DA 35/98 MOD 5 - Ixom Chlor-Alkali Plant, Botany Industrial Park - Response to Submissions

Table 2 DP&E Stakeholder Statements & Ixom Response

Figure 1 Possible alternative truck route to and from major arterial road (Princess Hwy)

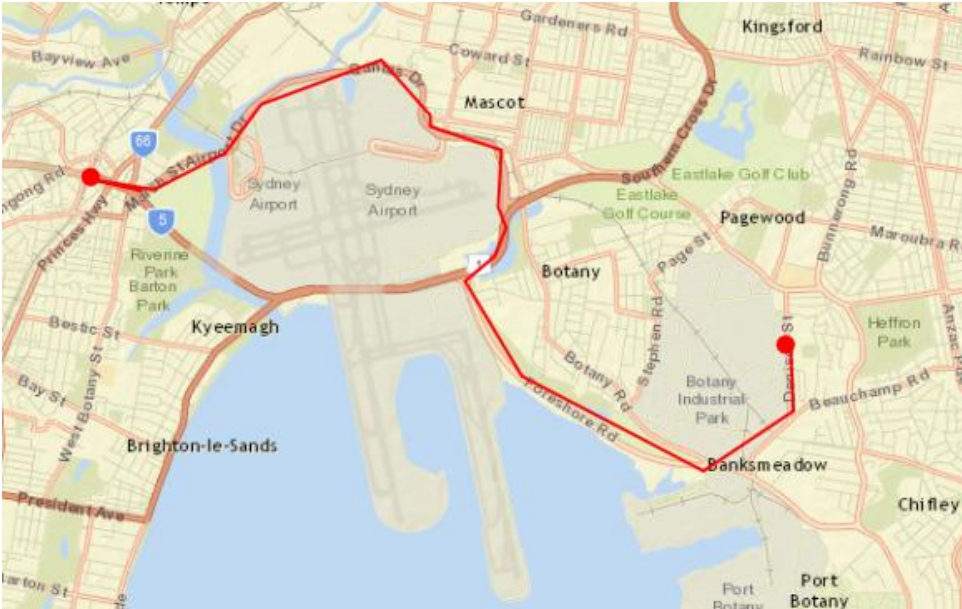
DP&E Stakeholder Statements	Ixom Response
<p>The Department has reviewed the modification request and supporting documentation for the Chlor-Alkali Plant, Botany Industrial Park (DA 35/98 MOD 5) and requests further information on the following:</p> <ul style="list-style-type: none"> Section 7 – clarification on the correct reference for ‘Section 0’ on Page 40 (section 7.1) and Page 52 (section 7.9). Section 7.2 – further information on the proposed construction and operational truck haul routes to and from the Site. 	<p>‘Section 0’ should be Section 3.5’ on Page 40 ‘Section 0’ should be Section 7.14 on Page 52</p> <p>It's difficult to predict exactly where the demand and market will be coming from. However, we can advise on possible truck routes to get from and to the arterial road from the Site. This is</p>

DP&E Stakeholder Statements	Ixom Response
	illustrated AUS16-23-PM-102_r0 Appendix A attached.
Requested a simplified drawing showing storage areas (acid/alkali), loading bay, entrance, exit, and filling.	See attached "Simplified Site Layout Plan.pdf"
In the RTS, please provide an explanation and justification for the proposed change (layout) and updated figures.	The reason the layout has changed is to improve traffic flow. See attached "Simplified Site Layout Plan.pdf".
<p>The Department understands the Botany Industrial Park (BIP) has undergone numerous subdivisions since the approval of the Chlor-Alkali Plant was approved in 1998.</p> <p>In your response to submissions (RTS), can you please confirm the Lots and DPs the Chlor-Alkali Plant including the Repackage Facility occupies within the BIP.</p>	Chlor-Alkali Plant including the Repackage Facility occupies Lot 110 DP 1204999.
